Monument Geomatics & Estimating Inc.

Re: 3852 Ganaraska Road Development, Garden Hill Estates

Revised Site Access Review

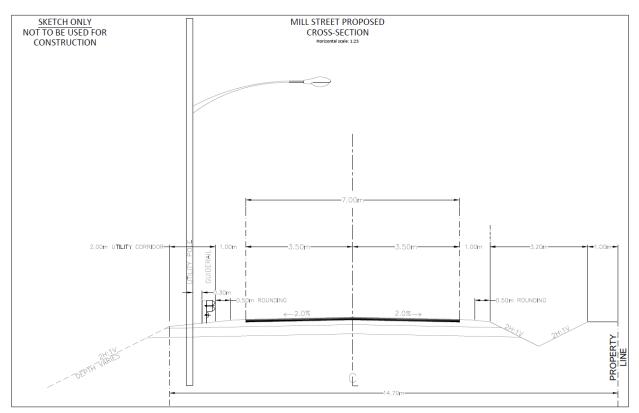
The image provided below is a screen shot of Mill Street right of way south of Ganaraska Road intersection. Mill Street is a rural cross section drained with culverts and roadside ditches. The cross section has a 6.5m asphalt platform with a 1.0m gravel shoulder and 0.5m rounding. Further to the south Mill Street transitions to surface treated with a 6.0m driving platform.

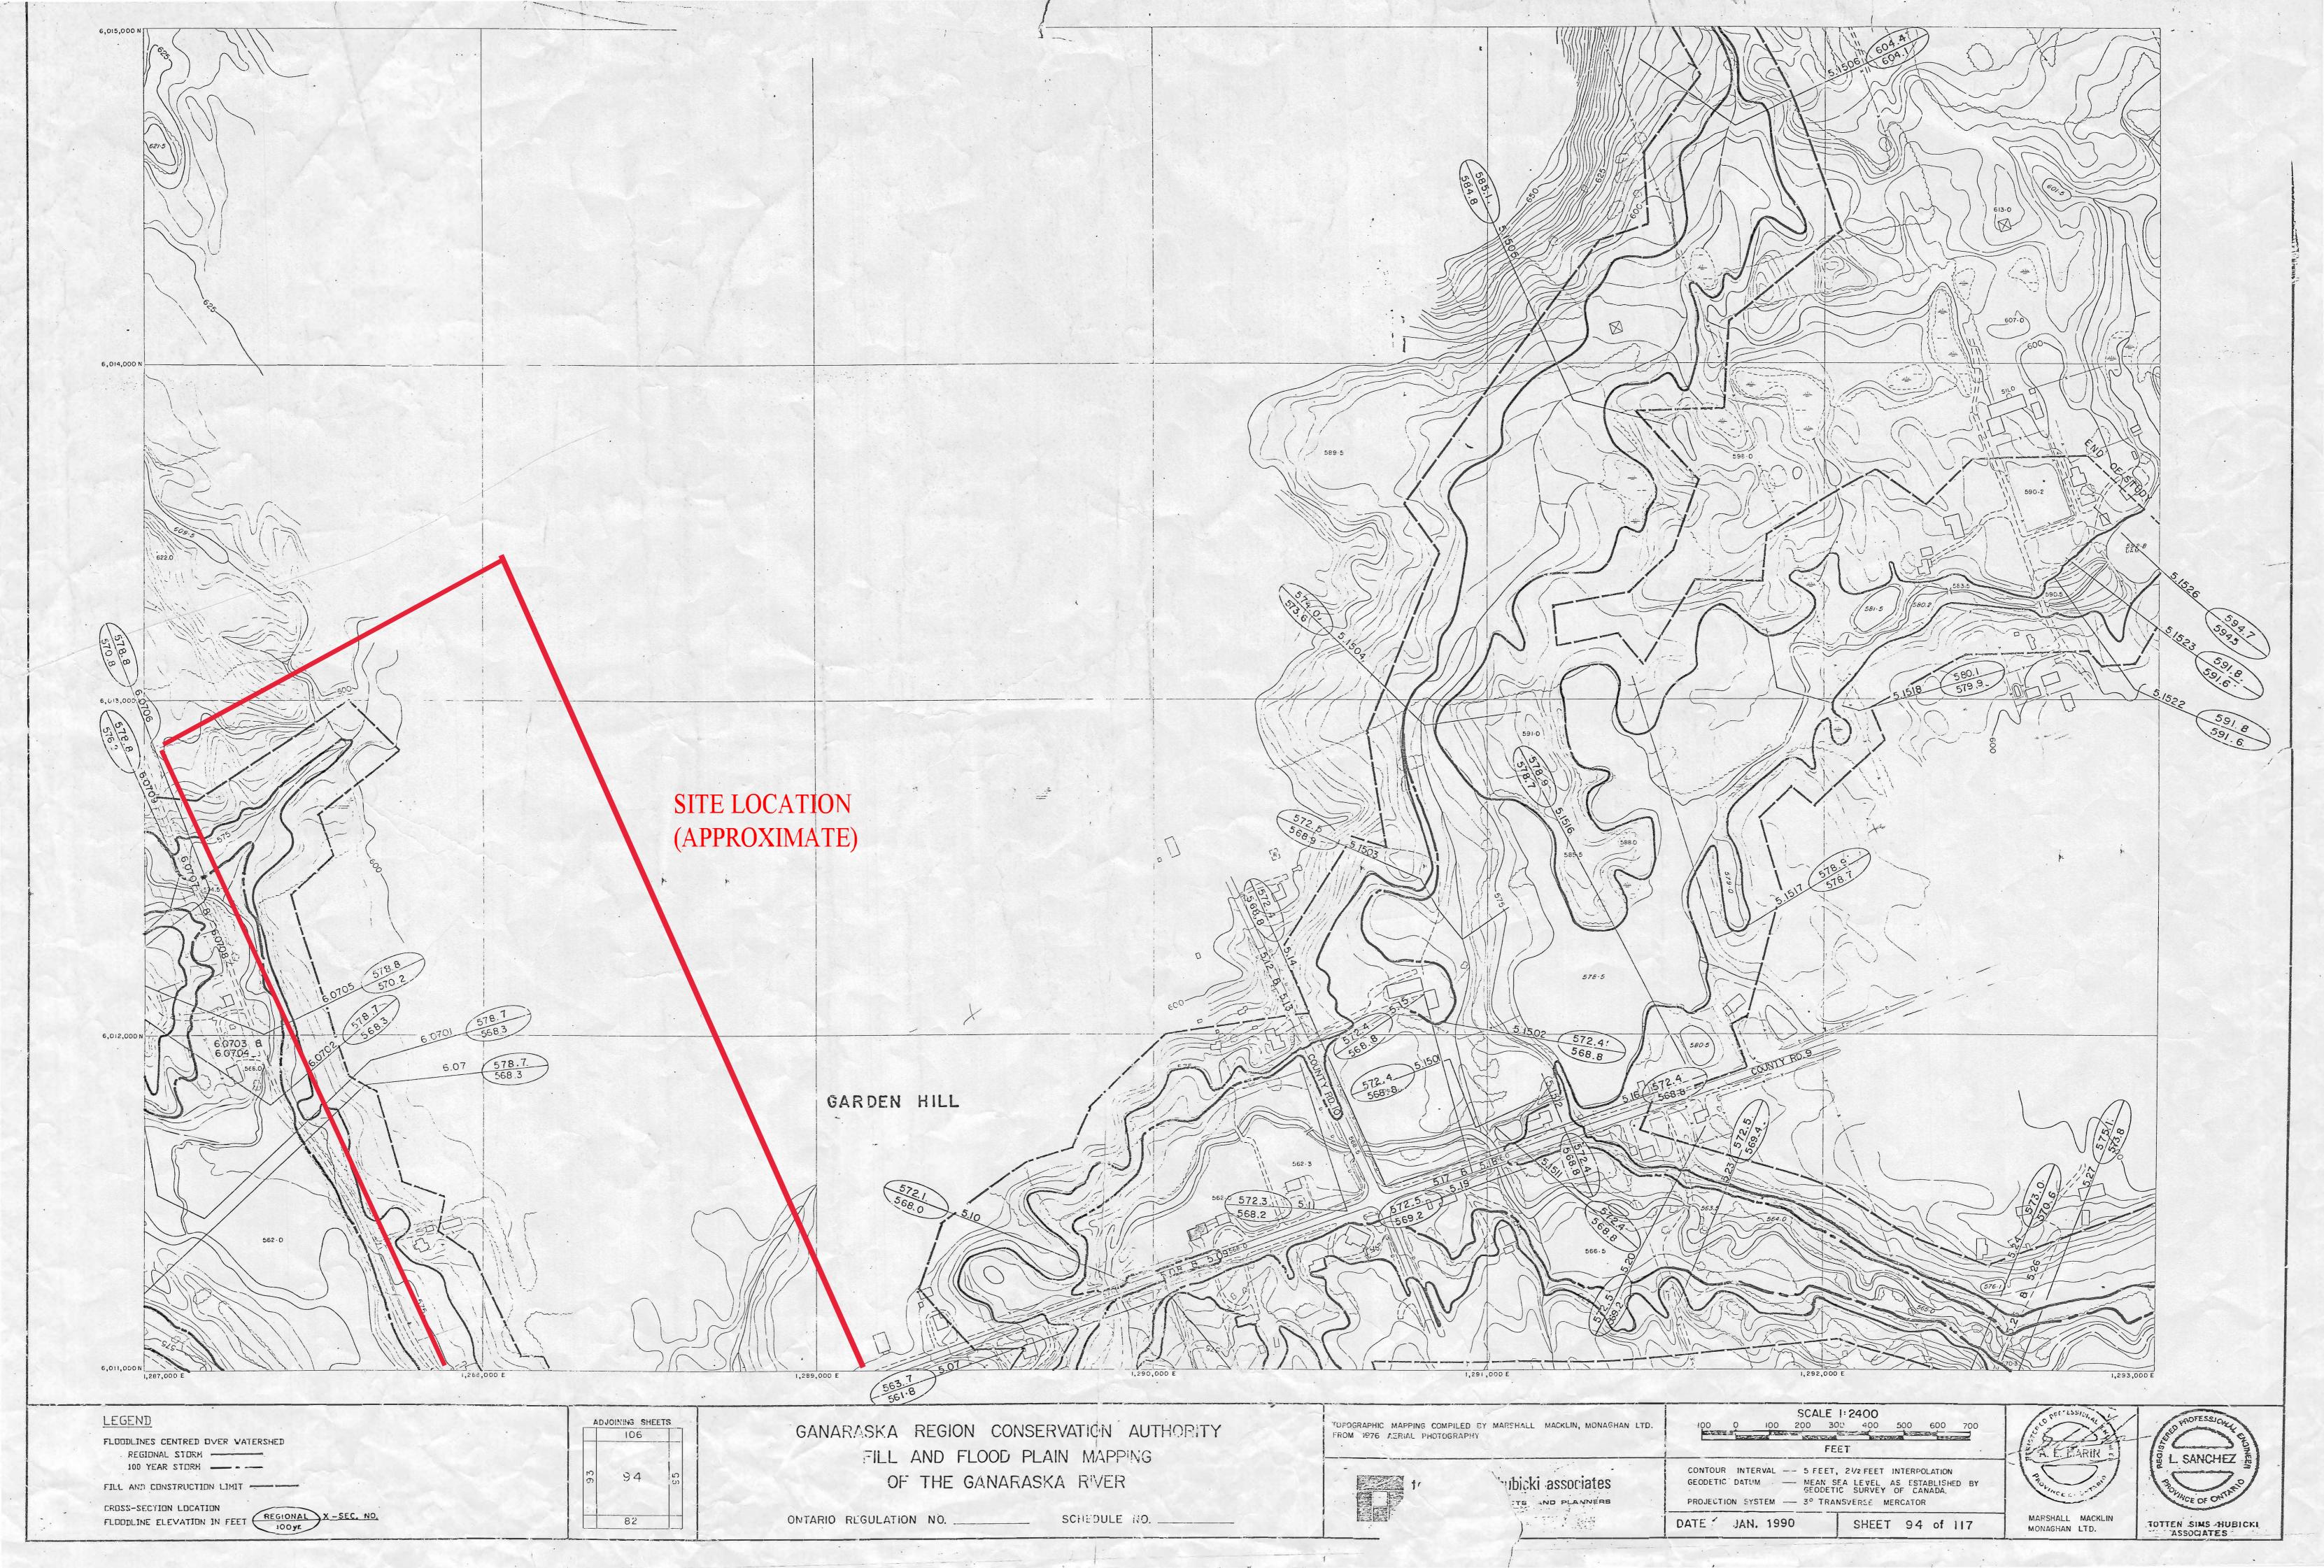
The site is located at 3852 Ganaraska Road in the Village of Garden Hill, situated in the Municipality of Port Hope and the County of Northumberland. As shown in the attached drawing (02), the site fronts along the Ganaraska Road (County Road 9) to the south and Mill Street to the west. Two dead ends terminate Porter Crescent (North) and Frost Avenue (South) servicing the adjacent Woodland Subdivision at the east border of the property.

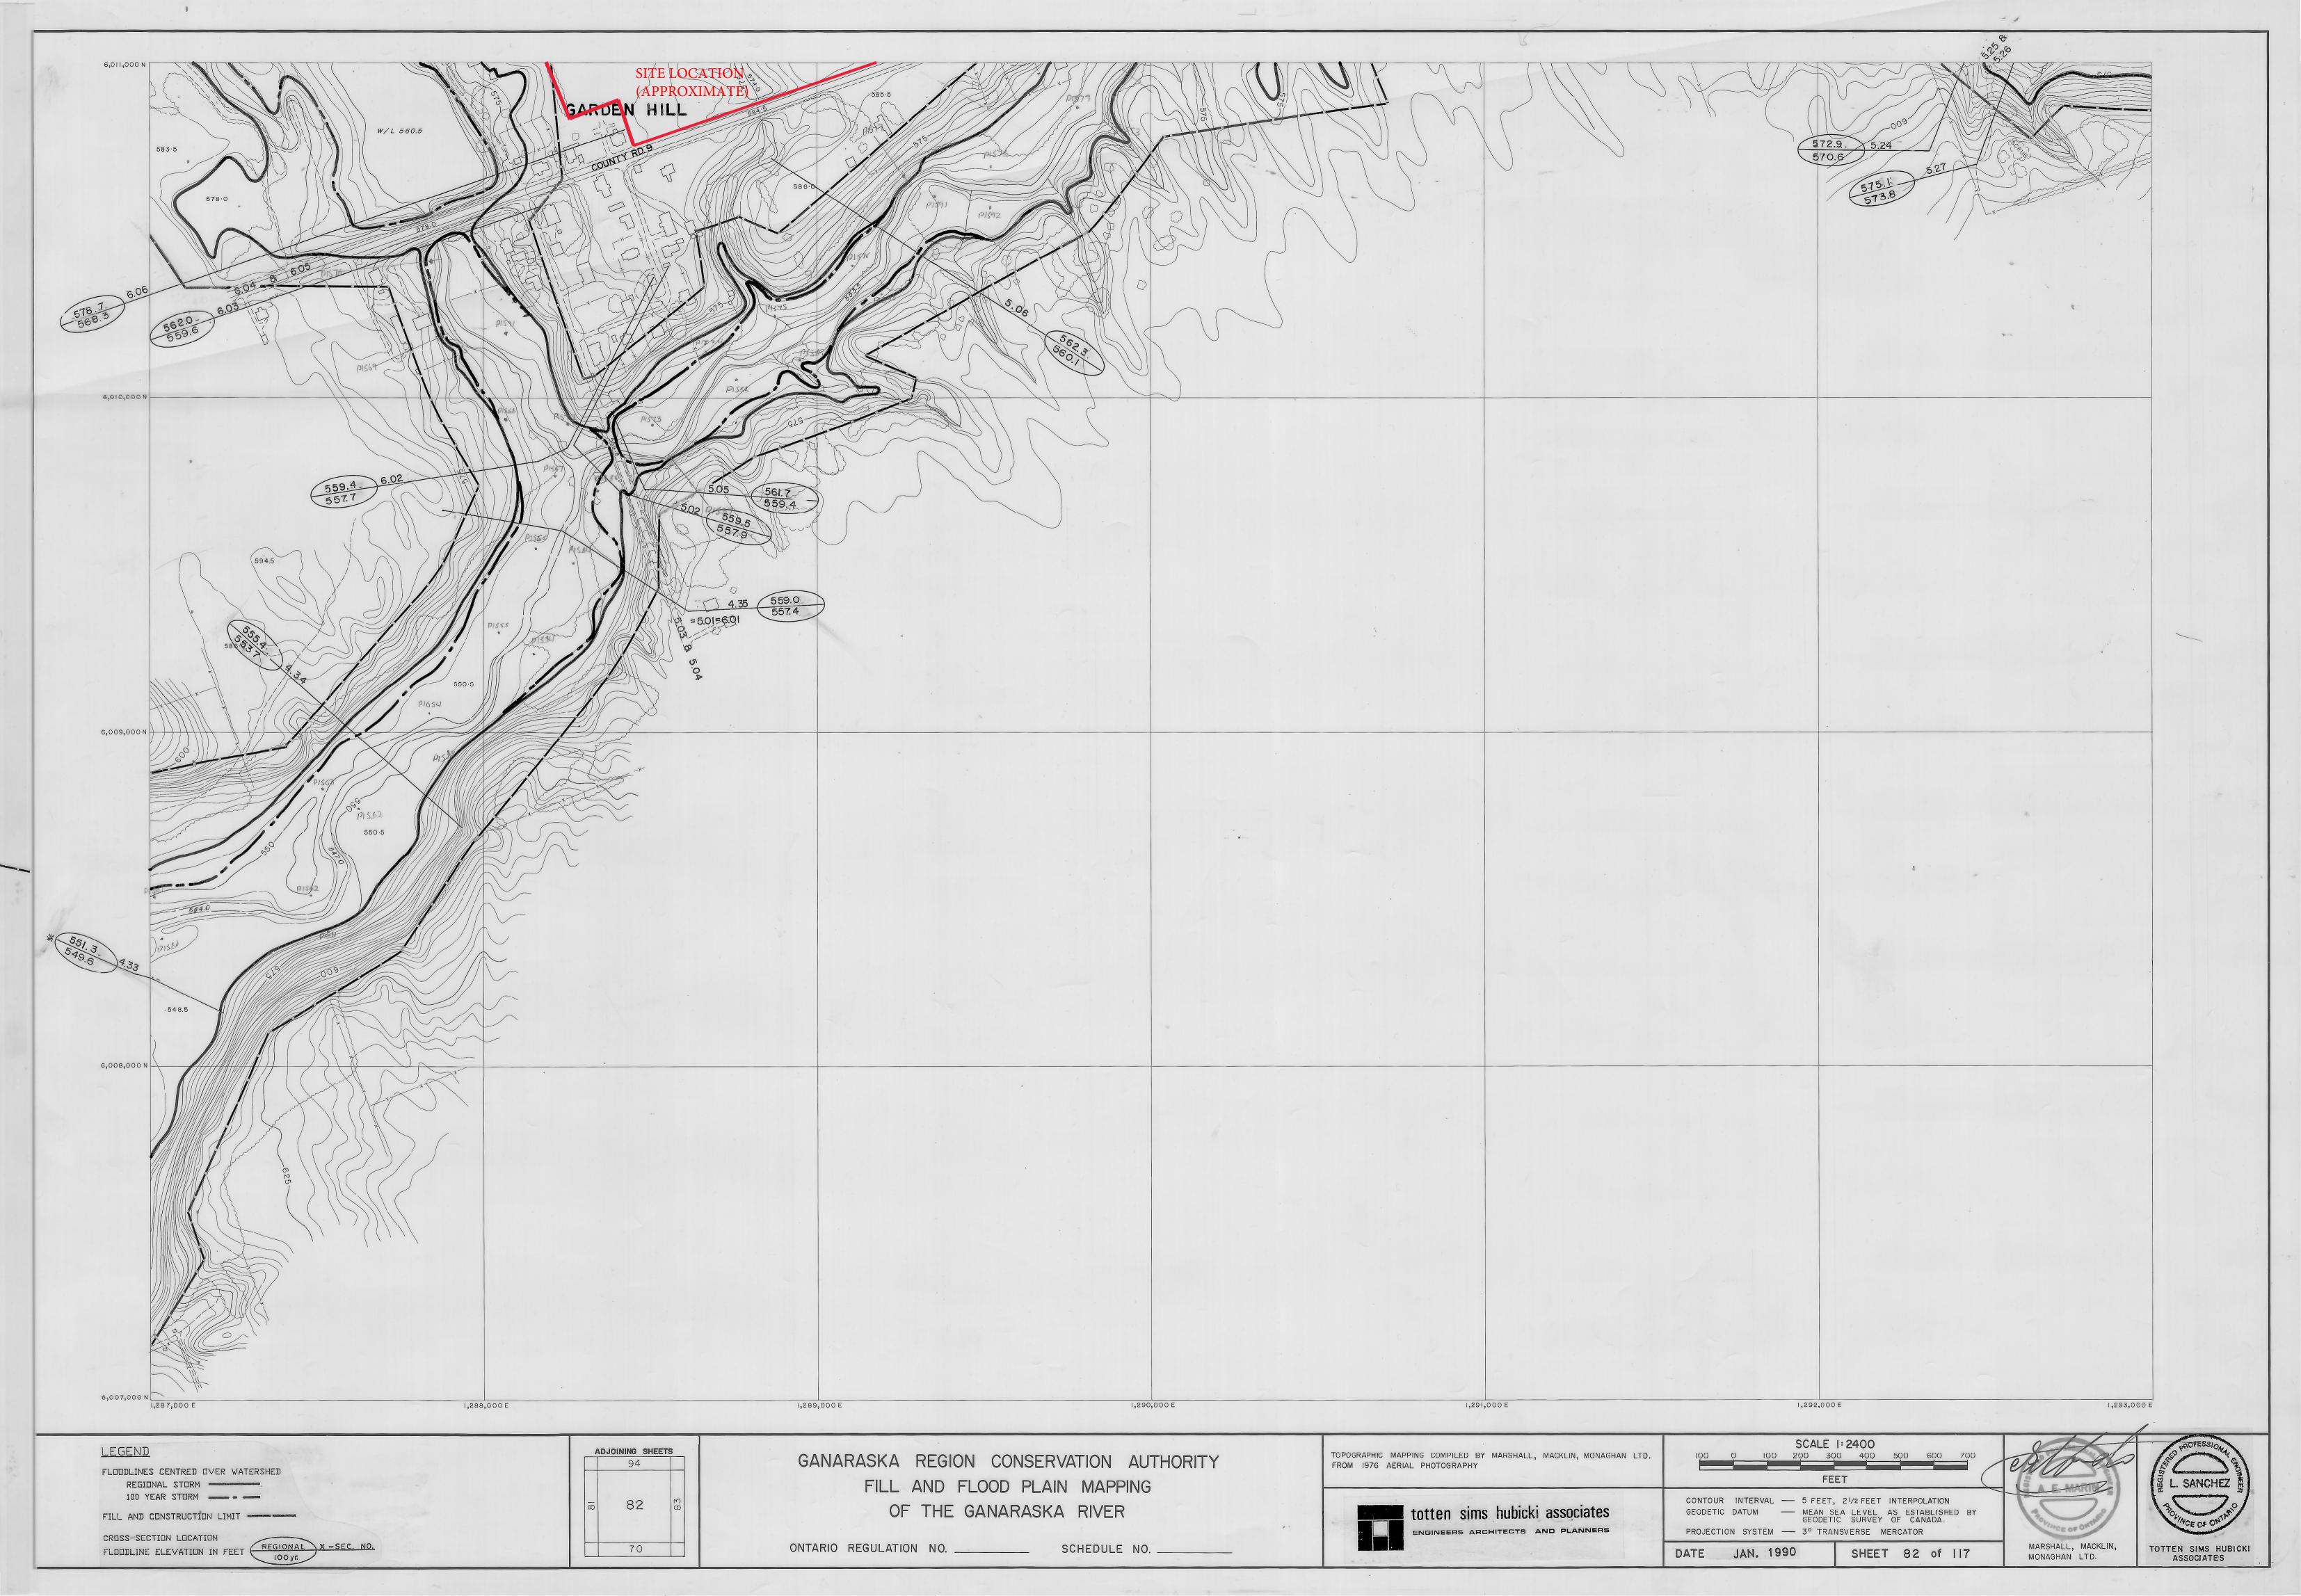
6) The proposed access point on County Road 9 be shifted east to provide approximately 200m separation from Mill Street and 110m from John Street without encroaching into the setback areas for the watercourse/tributary that passes through the Site and that the setback area be satisfactory to both GRCA and MPH.

The proposed access has been shifted east to meet the 200m separation from Mill Street as illustrated on the attached Draft Plan drawing (07). The wetland and watercourse setbacks are respected with the new access location. Floodplain limits are discussed in the comment below.
